WOODLAND GLEN SUBDIVISION

APPLICATION NUMBER 13 DATE September 17, 2009

DETAIL SITE PLAN

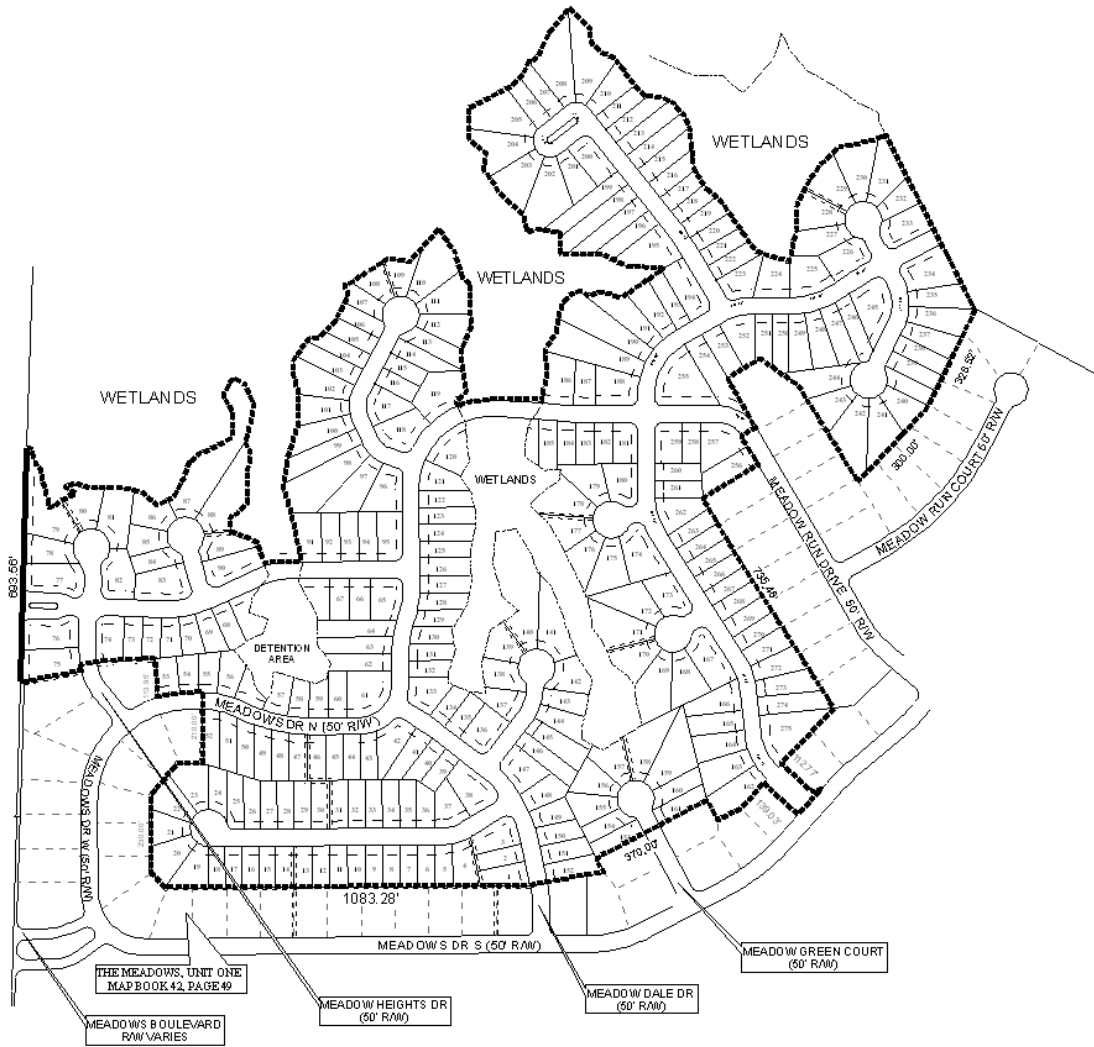
The proposed subdivision has frontage onto street stubs for The Meadows subdivision, all minor streets with adequate rights-of-way, and Schillinger Road South, a proposed major street with an existing right-of-way width of 80 feet. As Schillinger Road South is a proposed major street, its right-of-way should be 100-feet in width, thus sufficient right-of-way should be dedicated to Mobile County to provide 50 feet, as measured from the centerline of Schillinger Road South. With that said, the 25-foot minimum building setback line for all lots with frontage onto Schillinger Road South should be revised to reflect the right-of-way dedication.

Access management is a concern regarding the proposed subdivision fronting onto a proposed major street, and as it relates to lots within the proposed subdivision. One access to Schillinger Road South is depicted on the plat: a note should be placed on the plat stating that direct access to Schillinger Road South is denied for any lots fronting onto Schillinger Road South. Regarding the lots within the subdivision, a note should be placed on the plat stating that all lots (including corner lots) are limited to one curb each, with the size, design and location to be approved by the Mobile County Engineering Department and in conformance with AASHTO Standards.

It is very important to note that the increase in the number of lots was made possible with the reduction of the many lots with regard to size and width. While the sizes appear to be appropriate for lots with access to public water and sanitary sewer, many lots do not comply with Section V.D.2 of the Subdivision Regulations, which states that all lots must be at least 60' wide at the minimum building setback line. No similarities exist in the vicinity; The Meadows Subdivision (adjacent to the South and East), to which the proposed subdivision will have access, contains lot over 100' in width. Thus, no justification can be found to support the applicant's proposal and staff cannot recommend approval. However, if approved, a traffic impact study should be required to ensure that the site can accommodate the proposed number of lots, especially with only one access point for the subdivision to a major street. Furthermore, lot sizes (in square footage) should be provided on the Final Plat and the minimum front setback lines, where possible, should be adjusted to where the lots are at least 60' in width.

It should also be noted that the subject site is located within the Police and Fire Jurisdiction of the City of Mobile. With that said, the Subdivision Regulations have been amended since the original approvals to account for the 2003 International Fire Code. Therefore, if approved, this will require the revision of all cul de sacs (total of 10), which will further affect the size and shape of many lots. The applicant is aware of this concern and states that the increased right-of-way can be accommodated and still meet the minimum size requirement.

Based on the preceding, this application is recommended for denial because the plat does not comply with V.D.2 of the Subdivision Regulations and the 2003 International Fire Code.
